CLINTON CREEK MINE

REVIEW REPORT  
ON

WASTE DUMP AND TAILINGS PILE  
CONDITIONS

PREPARED FOR:  
INDIAN AND NORTHERN AFFAIRS  
YUKON WATER BOARD

FIGURE 1

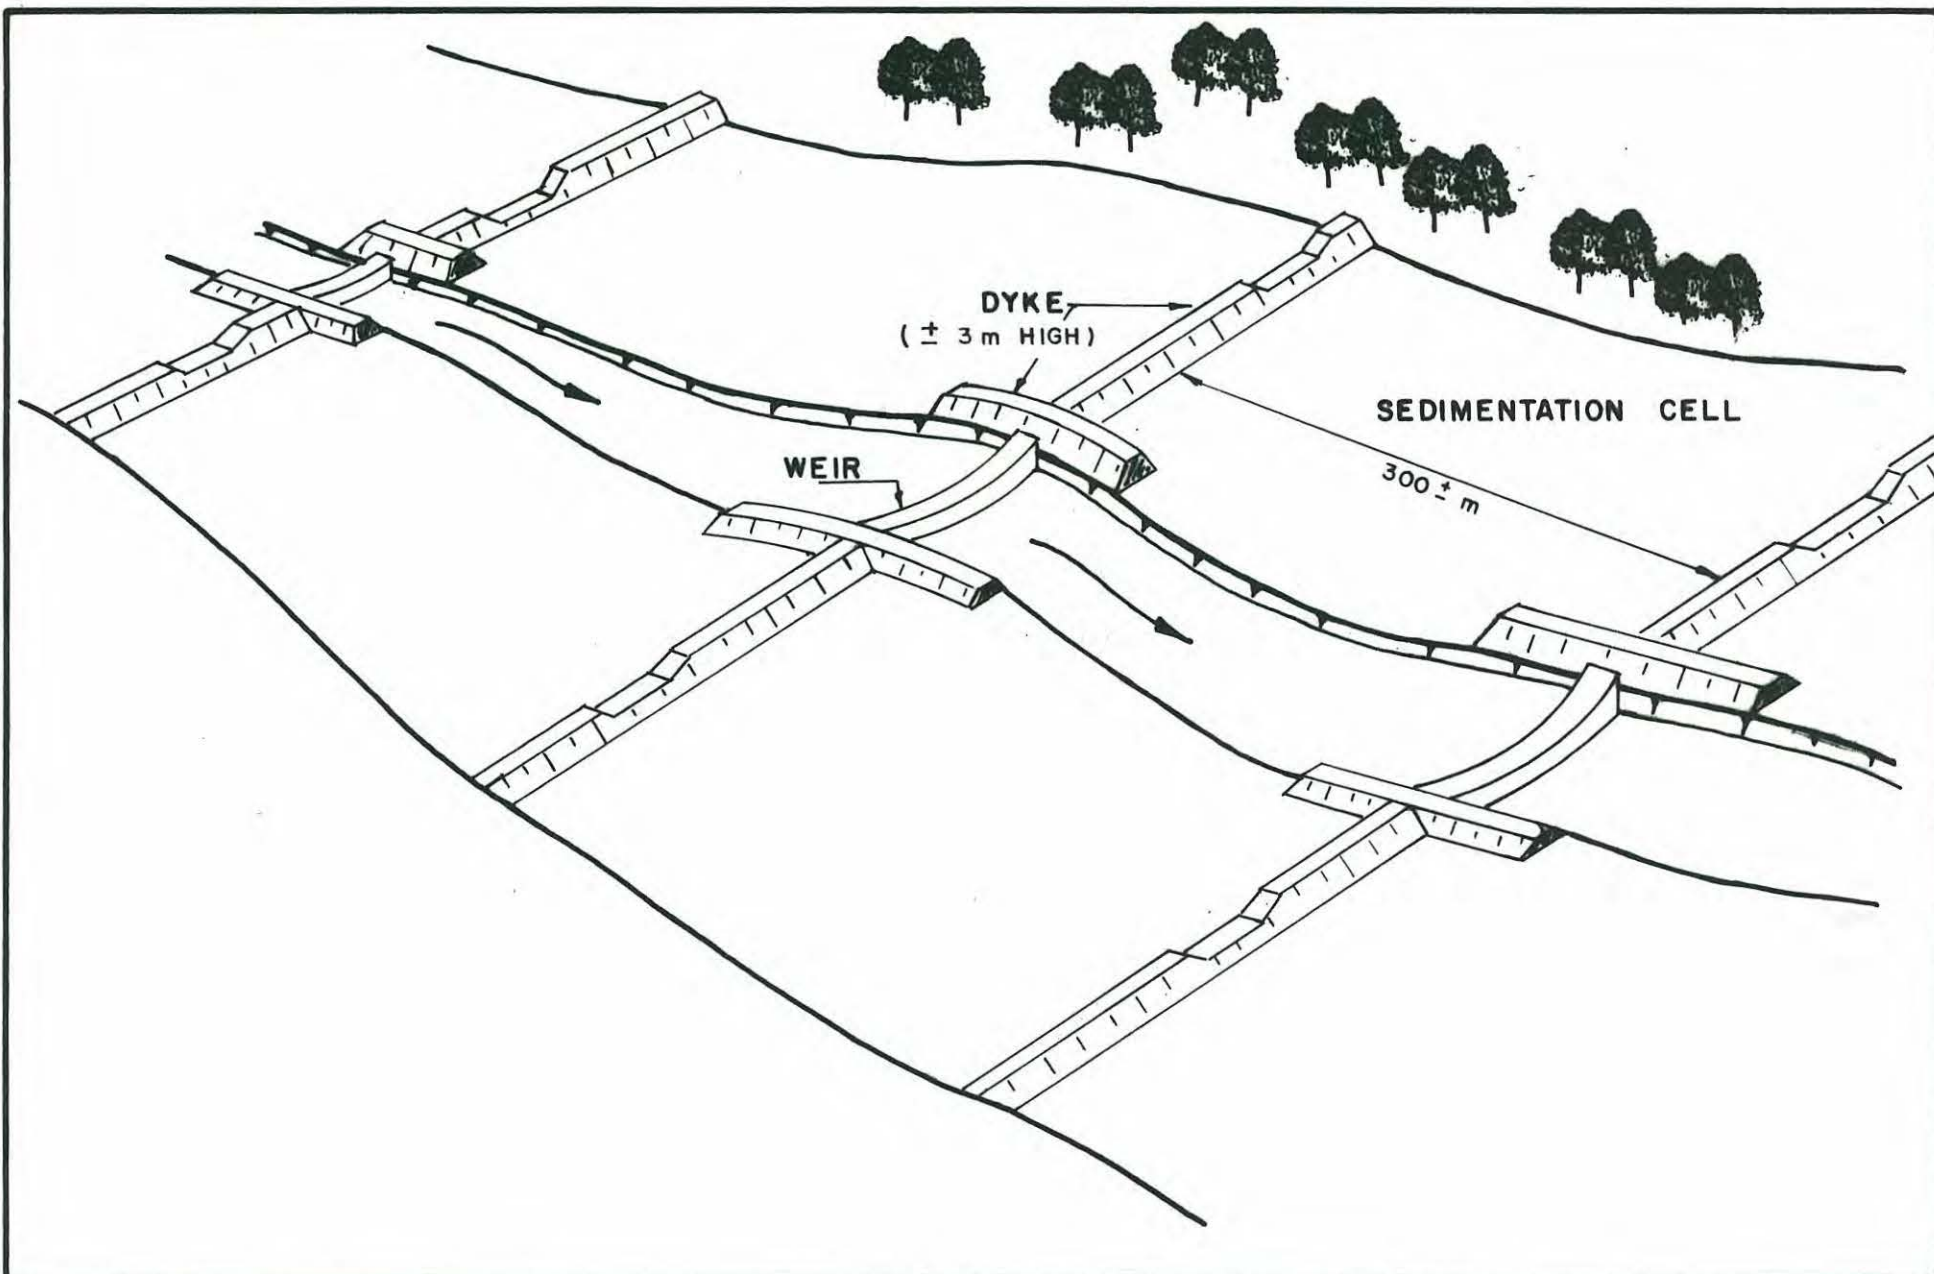
This arrangement would include construction of small flow and sediment controlling structures (weirs and dykes) at a distance of some 500 m downstream of the confluence of the Clinton and Wolverine Creeks. These structures would facilitate sedimentation of water transported materials during catastrophic or flood events and allow for more or less unobstructed flow and sediment transport during normal flow conditions.

These measures, schematically illustrated on Fig. 1 and 2, have been used on a number of European streams (to control sediment transport and facilitate navigation during low flow conditions) since the last century.

It is also recommended to evaluate the merits and costs of constructing a system of weirs and sedimentation cells controlling flow and depositional process downstream of the Wolverine and Clinton Creek confluence. The objective of these measures would be to provide a passive protection of the lower portions of the Clinton Creek valley and the Forty Mile River.

Further analysis and design is required to evaluate this scheme. It is considered to construct the flow and sediment control structures using mostly local material, i.e. timber and earth compacted dykes. Stream and bank protection may require gabion mattresses or baskets.

**FIGURE 3**

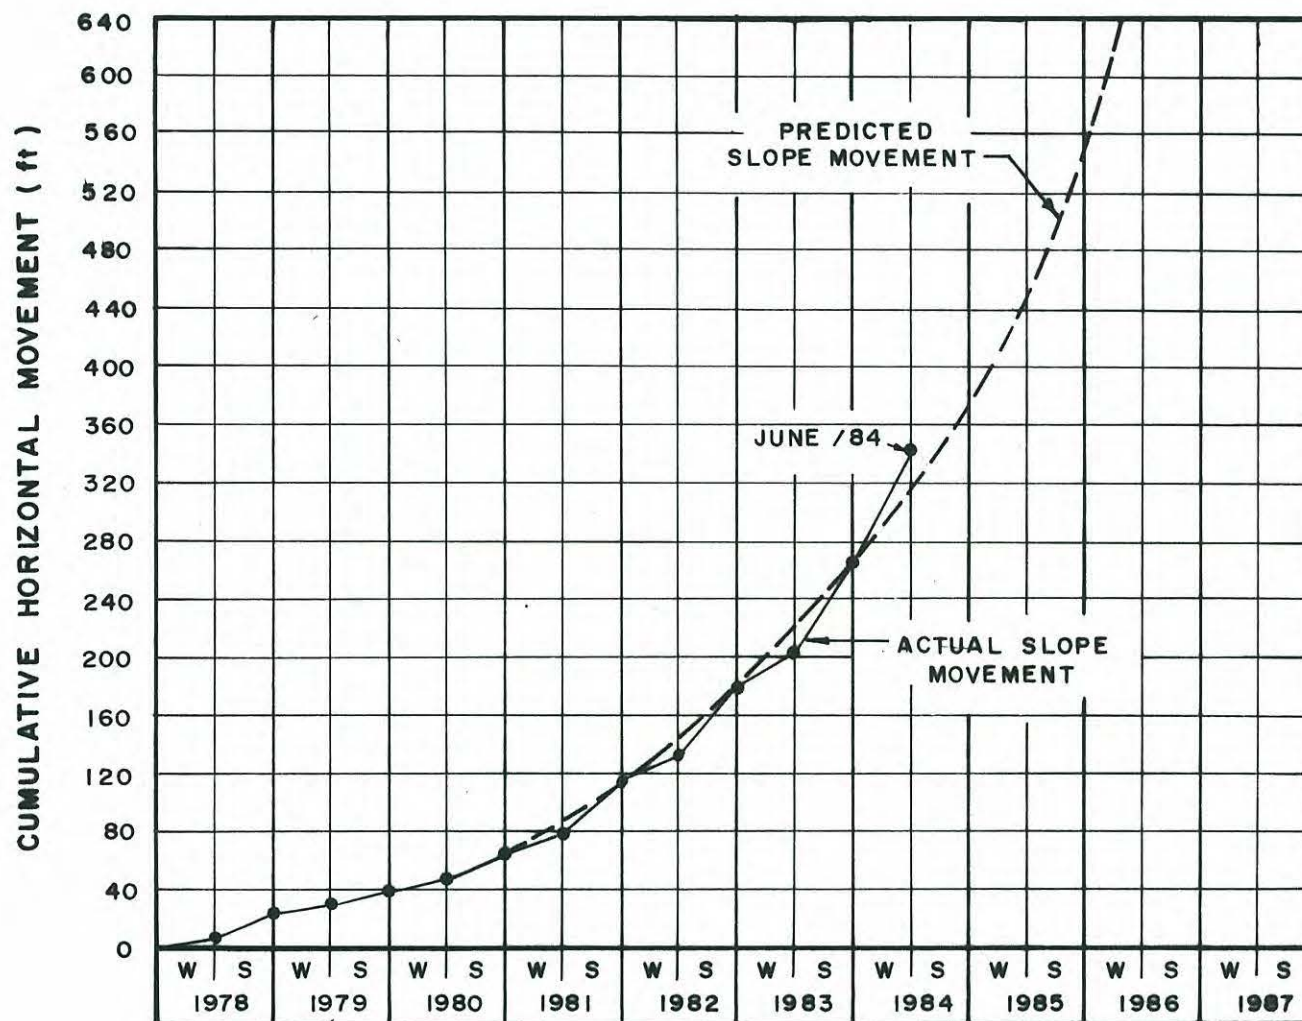
It is not believed that the current state of the Clinton Creek waste dump ensures reasonable stability of the lake, its outfall and immediately adjacent stream channel. As illustrated by Figure 3, the rate of the waste dump movement has been relatively constant since 1982. While a catastrophic failure of the dump or a sudden breach of the valley blockage is not expected, the erosion of the dump will continue for many years. This, in my opinion, will eventually lead to the failure of the lake outfall structure, to partial removal of the waste dump which, in turn, will cause a temporary acceleration of waste dump movement and deposition of large quantities of materials further downstream. This process
